NOV_SCE_ATJ_ 20211115-01

NOTICE OF VIOLATION

Energy Safety Inspection Report

Report Name: SCE_ ATJ_20211115-01

Structure ID: 4194263E

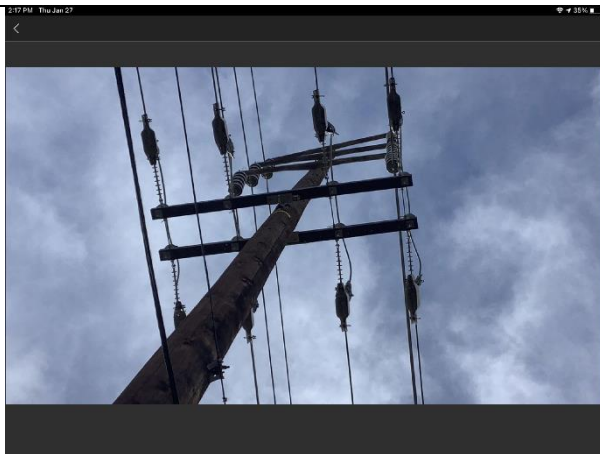
Item3IA1img1: Vibration dampers not installed

Structure ID: 1473789E

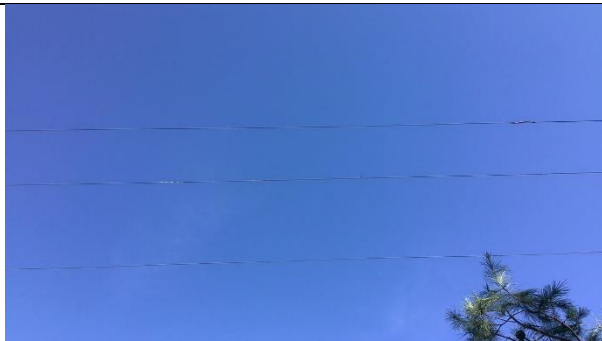
Item7CD4Img1: Overall view of pole looking East containing three splices

Item7CD4Img2: Close up of frayed conductor

Item7CD4Img3: Two splices and frayed wire

Conductor Question #9 Photo

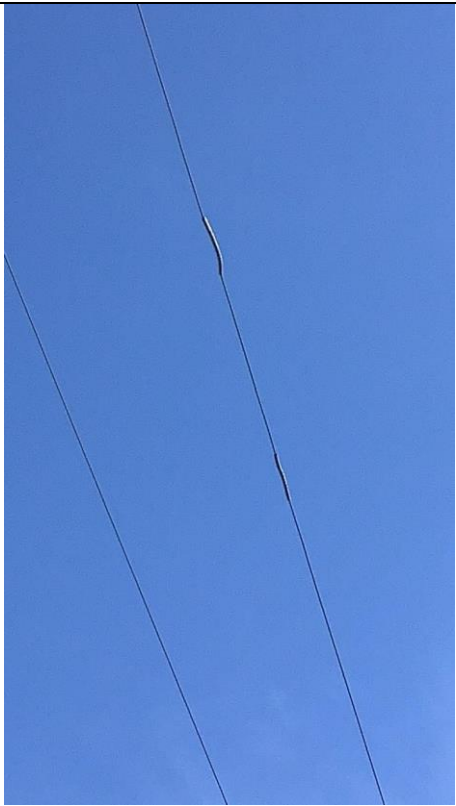
Item7CD9Img1: Two splices on one phase

Item7CD9Img2: Third splice on same phase
